SHEET 3/5 COPY 3

Project Title:
Proposed Additions & Alterations
LOT 913 of Pinetown Township
28 Livingstone Road

Drawing Title:
Fire Plan

1004/04 Revision A

FIREPLAN
SCALE 1:200

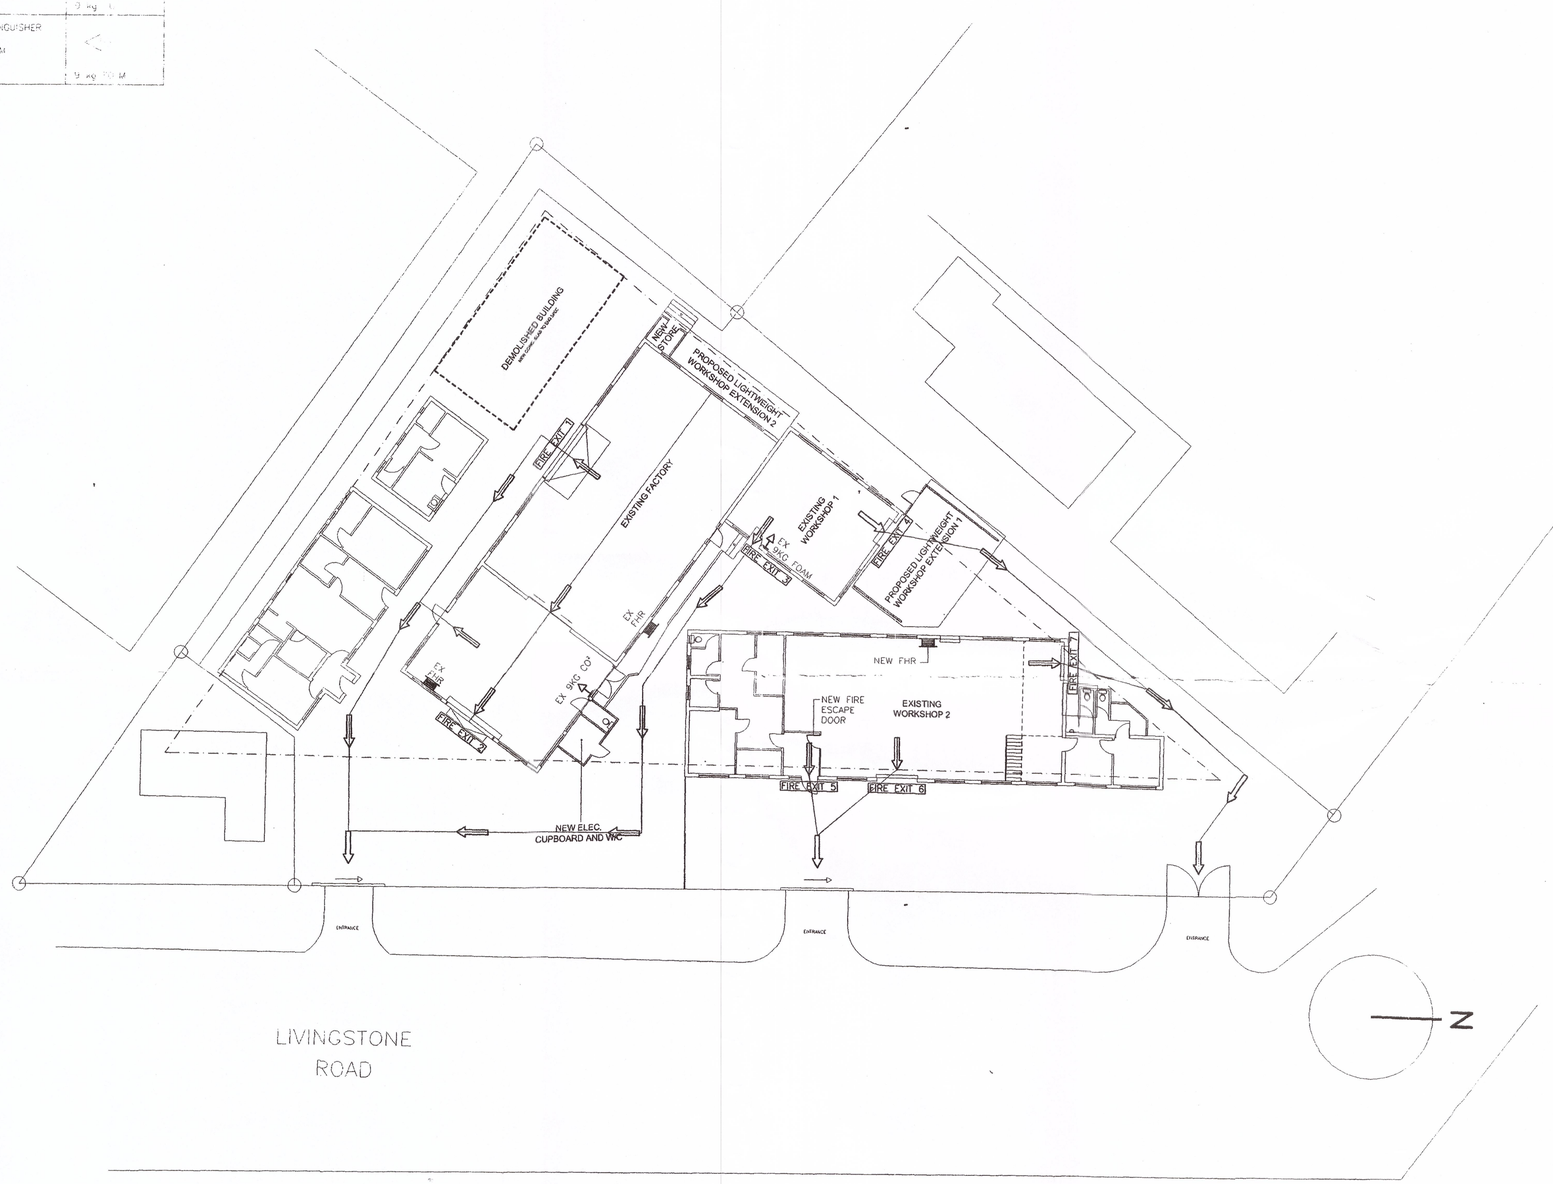
REVISION:	DATE:	DESCRIPTION:
A	07.04.10	**FIRE:** Peter Nzimande

- Fire plan updated to comply with A5 of SABS 0400-1990
- Fire notes updated to specify the TT section of part T fire protection of SABS 0400-1990

- Gridded channel and 1mx1m wash gully added to proposed light weight steel structure in front of roller shutter door, and connected to sand oil and grease trap that drains to existing council sewer

- Wc updated to comply with part O of SABS 0400-1990 for natural lighting and ventilation
- Wall at lightweight workshop extension updated to comply with assesment officer
